Broadway and 8th Street Project – Documentation to be attached to the presentation to City Council
by G. Thorinson

Conclusions of the following Critique of the Proposed Project at Broadway and 8th Street

Massing and Angular Plane Guidelines

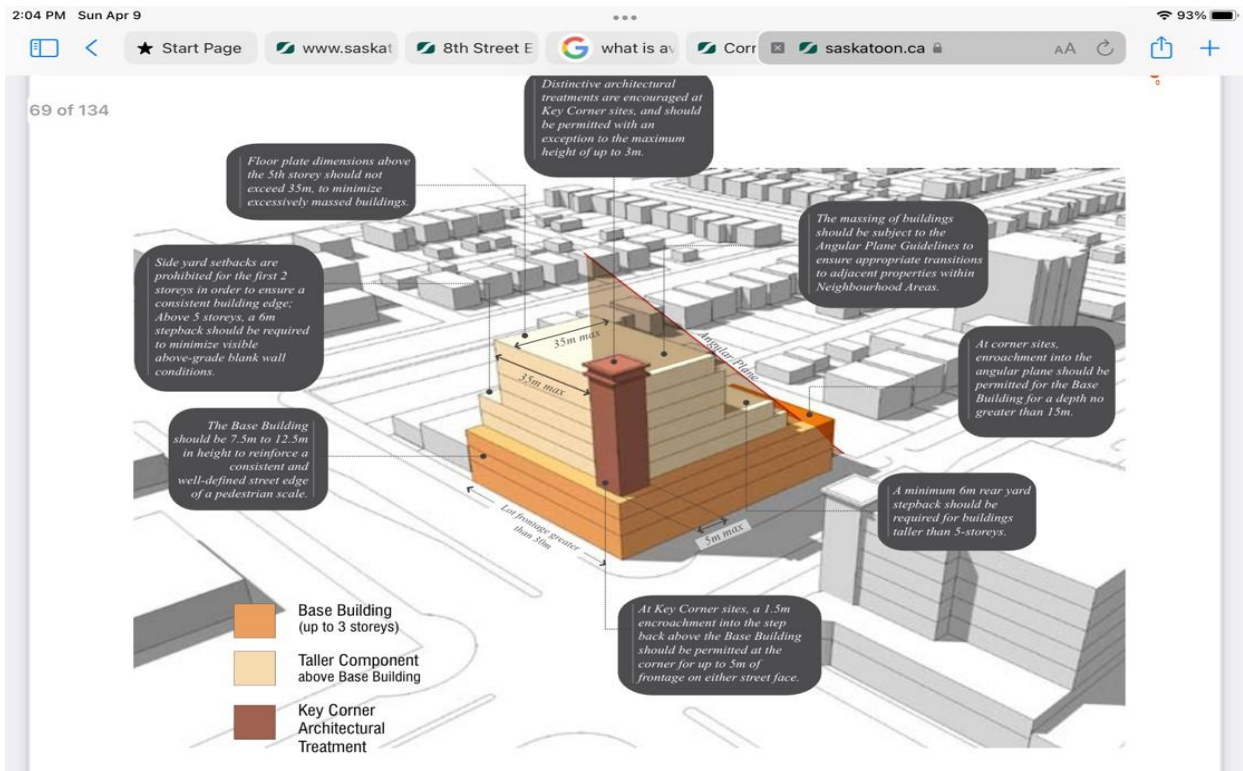
- To avoid encroachment the guidelines suggest a 45 degree angle from the top of the building to the end of the lane behind. Using this formula and the distance proposed – **we get a 2 story building at the northwest corner and a 2 story building at the southwest corner. The proposal is far too large in all aspects but at these critical points there will be far too much shading and also there will be an accident prone turn at both points. As you can see in the photo there is a tight turn at both locations, both of these points will be high risk for automobile accidents with pedestrians, cyclists and passing motor vehicles.**
- Using the 45 degree angle the building is non conforming in over half of the footprint. While a slight deviation might be allowed at a key site like this one, 4 floors over good guidelines would be out of the question.

Angular Plane Guidelines: Note the key architectural treatment request (not present) and tapering that would be required at this site. As can be seen from the developers plans he is making a monolith, creating an unsightly, non conforming building. These guidelines were apparently ignored to maximize the profit for the builder.

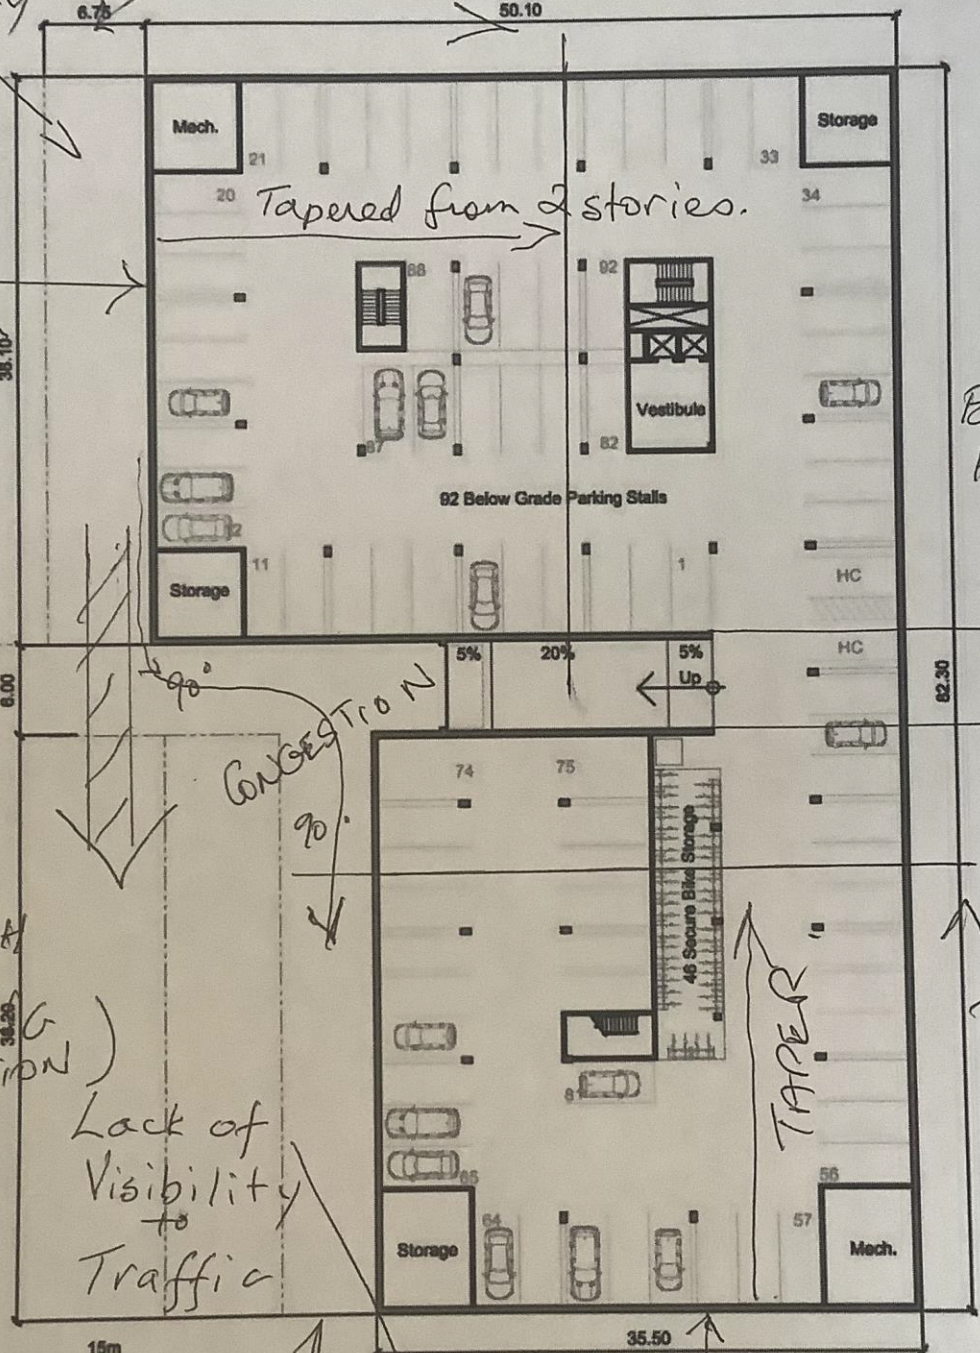
Lack of Visibility

High Accident Zone
Too Close to R2 Property

2 Stories Maximum

Tapered from 2 stories.

ENTRY/EXIT POINT NEEDED

LANE SHOULD BE STRAIGHT THROUGH (PREVENTING CONGESTION)

CONGESTION

Lack of Visibility to Traffic

TAPER

Tapered from 2 stories

High Accident Zone

2 Stories Maximum
